R2 RE

APPLICATION FOR PERMIT

Jamuary 23, 1953

BUILDING PERMIT REPORT

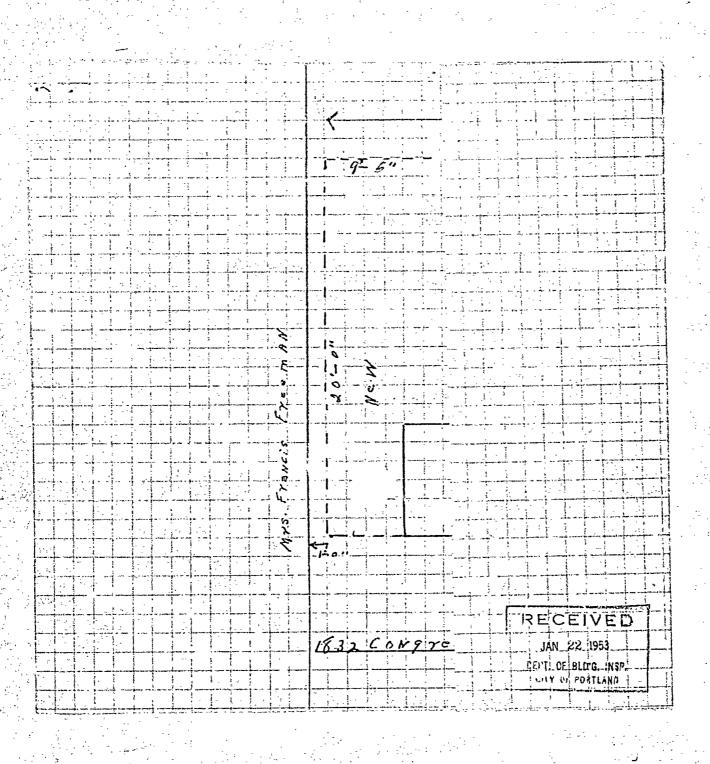
However, the location plan indicates that the main wall of the addition would be only one foot from the side property line and that the caves of the addition would everhang six in. Thus it would seem that the edge of the caves is intended six in. from the side property line. The Building Code, aside from Zoning requirements, requires in a manner not subject to appeal that the edge of the caves or what we call the "drip" zonst be at least two ft. from the side property line.

The Zoning Ordinance requires at least three ft. from the main wall of the addition to the side property line if the front of the addition would be at least 50 ft. from the street line of Congress St. (inside edge of Diture public sidewalk). If the front wall of addition would be closer than 50 ft. to the mirest line, than the distance from side wall of addition to side property line is five ft. These distances are subject to Variance Appeal to the Zoning Board of Appeals.

However, it would be useless to seek such a Zoning Appeal, since the Building Code will not allow the addition to be as close as shown.

If you wish to revise the proposition so that the overhang of eaves would be at least two ft. from the side property line, then you are in a position to file a Zoning Appeal. Otherwise, it is no use to plan further, and if Kr. Kelley will return the receipt paid to this office, the money will be refunded by voucher.

If you decide to cut down the width of the addition to coincide with the above, it is necessary that you file a revised location plan showing the distances required by the Building Gode, then file appeal under the Zoning Ordinance seeking a variance of those requirements. At the same time it should be made clear whether or not the front of the proposed addition would be 50 ft. or less./file investible. location plan indicates "about 50 ft."
